城規會編號：TPB/A/YL-SK/435

提議雨水渠務報告 (Proposed)

事項：回覆 2026 年 1 月 12 日信函的部門意見

A_YK-SK_435

Photo c3-2

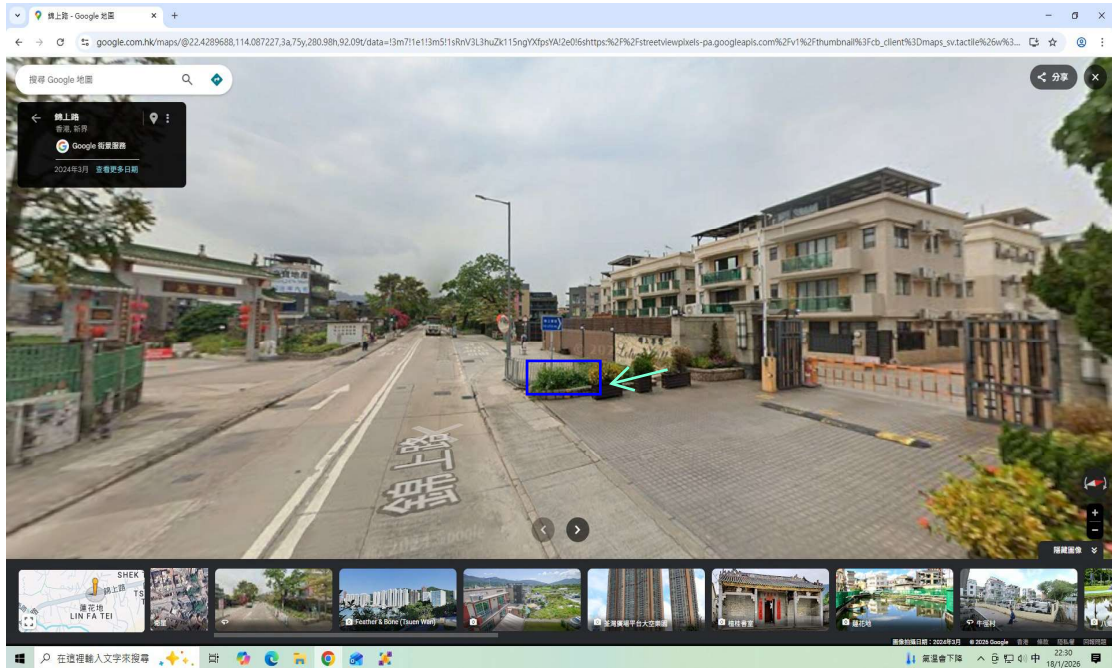
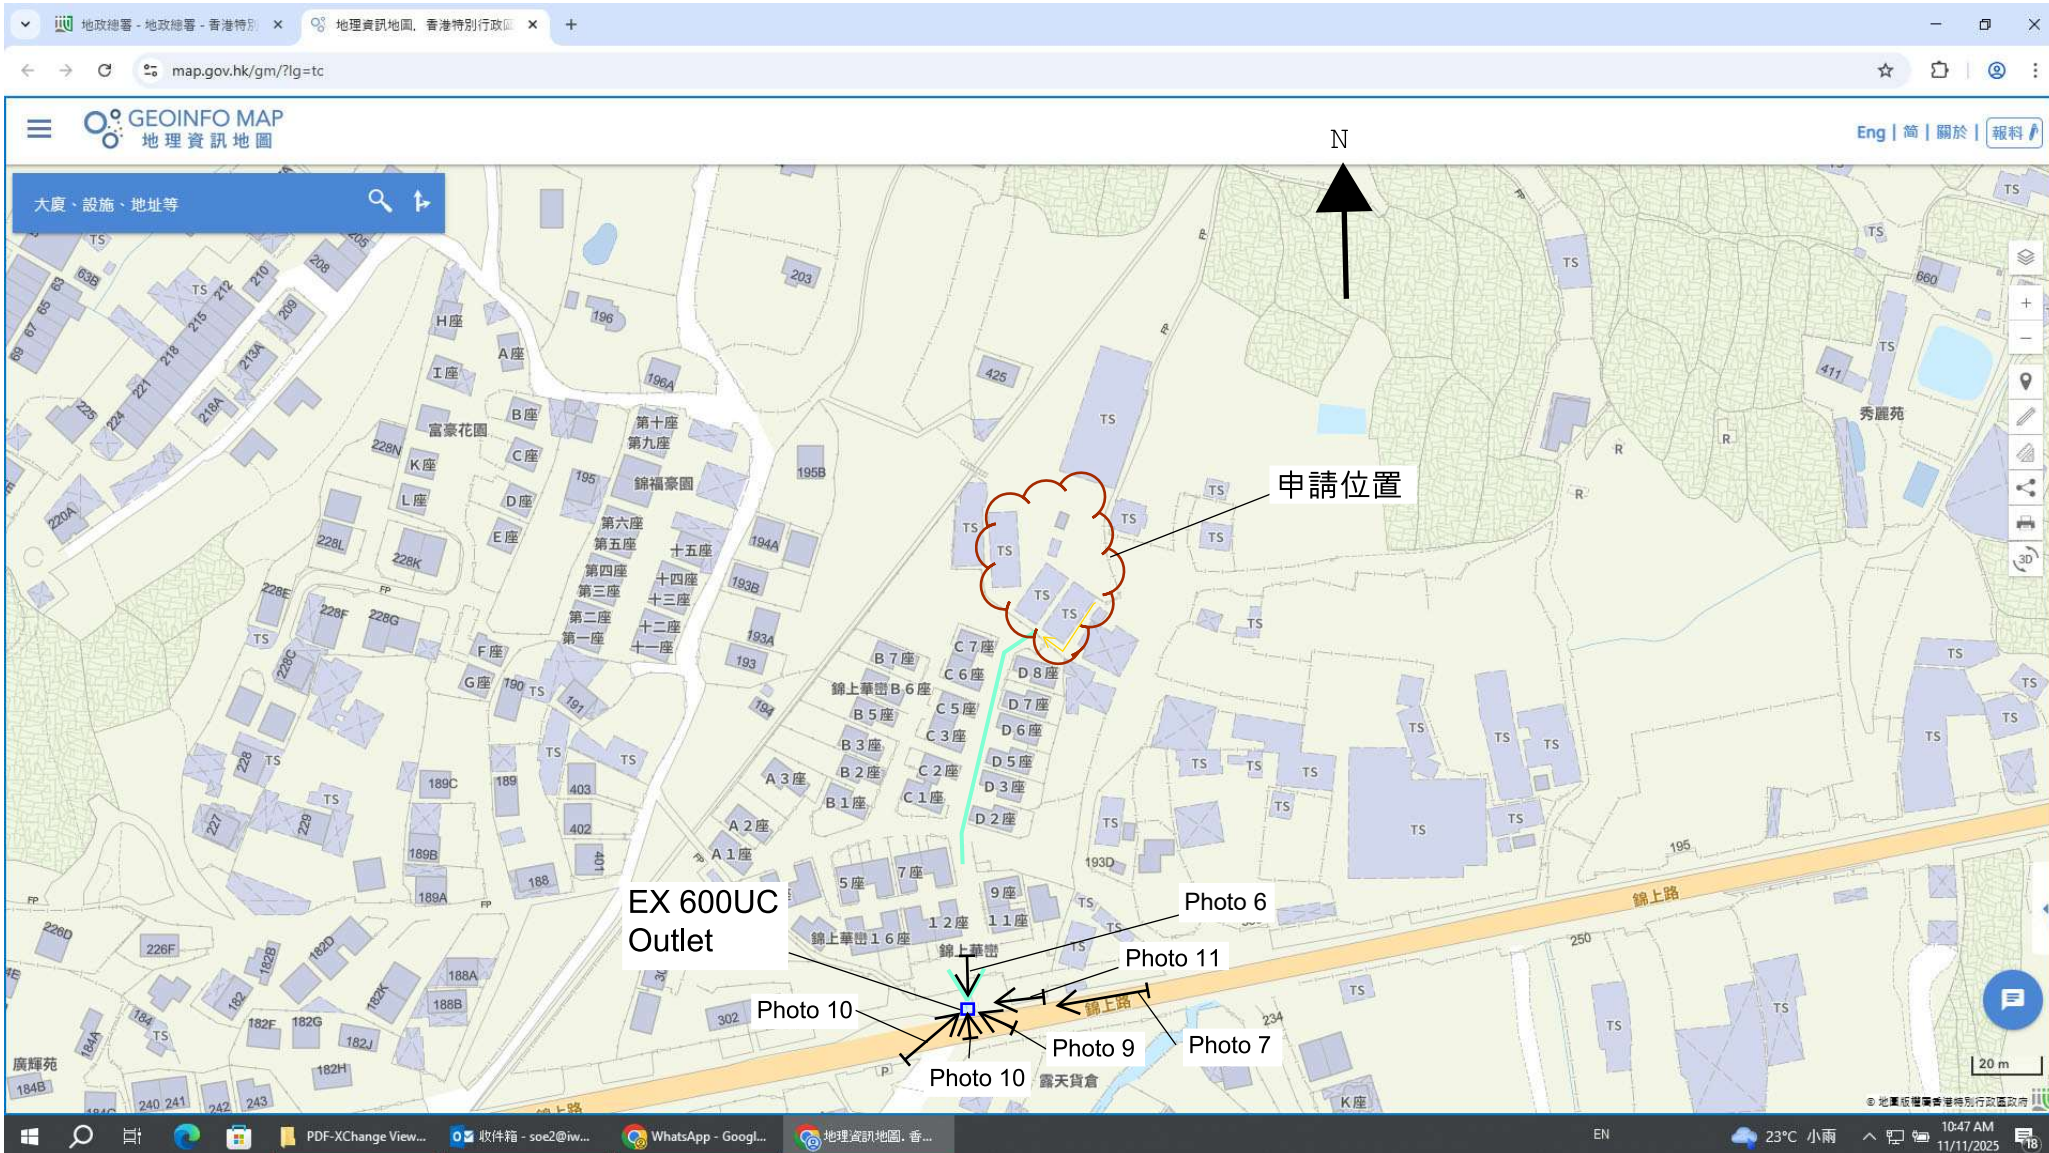
(d) The submitted site photos cannot indicate and show the current conditions of the existing 600UC. Please provide more site photos at different views and locations for review.	在c3-2和4-2中示

SK/435

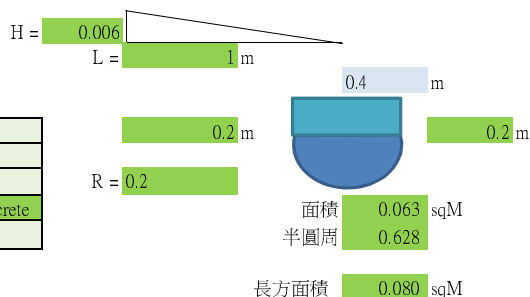
20260112 Comment	回答
(a) The drainage system from the application site of A/YL-SK/421 was proposed to be discharged to the proposed u-channel between CP6 and CP7. Please take into account the increased drainage quantity for the assessment. Please also make reference to the latest Technical Note No. 1 issued by DSD for more details in preparing the drainage proposal. Please upgrade all drainage facilities size and/or gradient accordingly.	在e1-2 至e3-2中示, 附件1至附件4(SK/421)資料

SK/435 Proposed 400UC		Concrete	0.14465
L =	143.2	L =	143.2 m
H =	0.3	H =	0.3 m
A =	1368	A =	1368 m ²
		$t_0 =$	12.80 min

50 Year Rainwater Intensity	intensity	185 m/hr			加16%
		0.185	/	3600	*
	intensity =	5.9611E-05 m/s

C =	0.9
i =	5.96E-05 m/s
A =	1368 m ²
$Q_p =$	0.073393 m ³ /s

Area	=	0.08+0.063	0.1428
P	=	0.2*2+0.628	1.028
R _n	=		0.138911
n	=		0.016 Concrete
S ₀ = H/L	0.006	1	0.006

SK/435 & SK/421	% =	0.185305
	% =	0.085875
Q(m ³ /s) =	46.3 %	OK

Drainage Impact assessment report of 400 mm channel is Acceptable
